Subject: FW: Crete Nursery, Dappers Lane, Angmering - Culvert - Condition 10

Additional information for consultee response – Land Drainage Condition

Following Paul's e-mail confirming the Land Drainage Consent, please find enclosed a copy of the approved drawings for the discharge of Condition 10.

Dappers Lane
Angmering
Drainage Layout
Site Plan

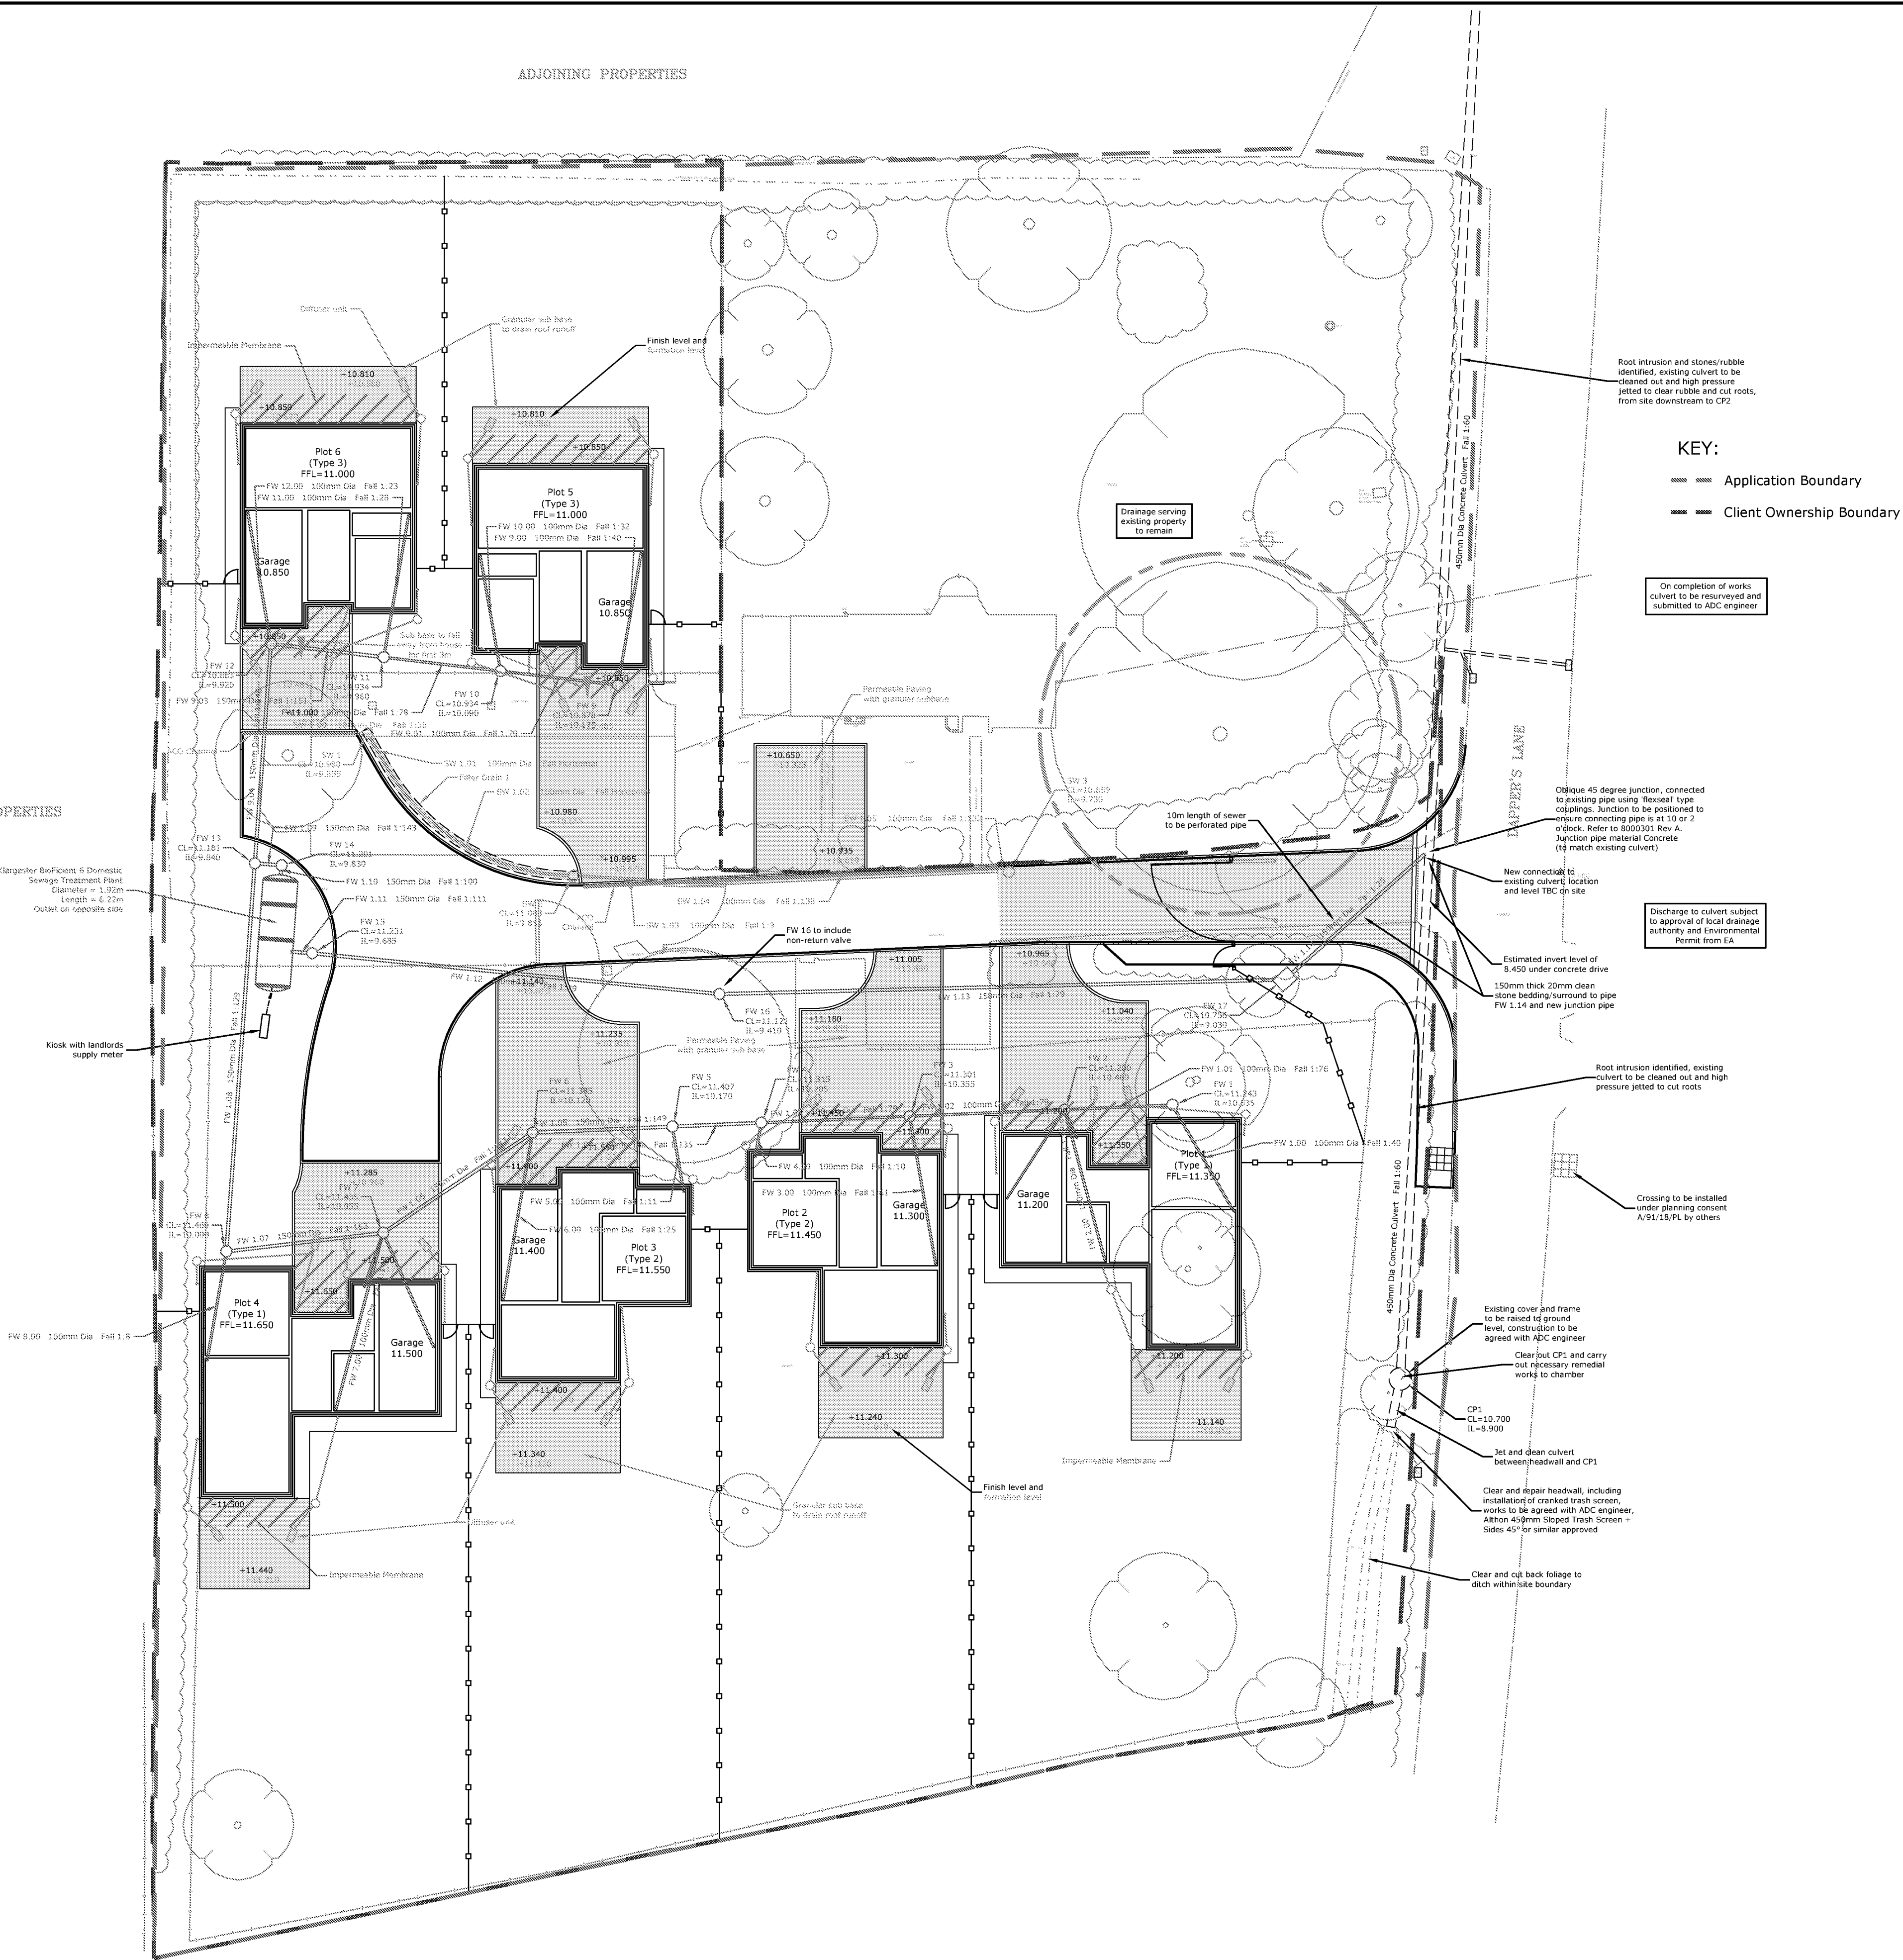
The proposals seem reasonable. Regarding the root ingress, they will need to keep on this in the future (after cleaning) to ensure that flows are not restricted.

In respect to the headwall repairs and trash screen proposal – that is fine. Please add suitable notes – I suggest that the note mentions that the works need to be agreed with the ADC engineer. Also, the trash screen will need to be a cranked version – see <https://www.althon.co.uk/products/450mm-sloped-trash-screen-sides-45/detail/> for example. Please specify the detail/manufacture on the drawing.

Thanks for your comments, we have added these notes to the drawing, please find enclosed.
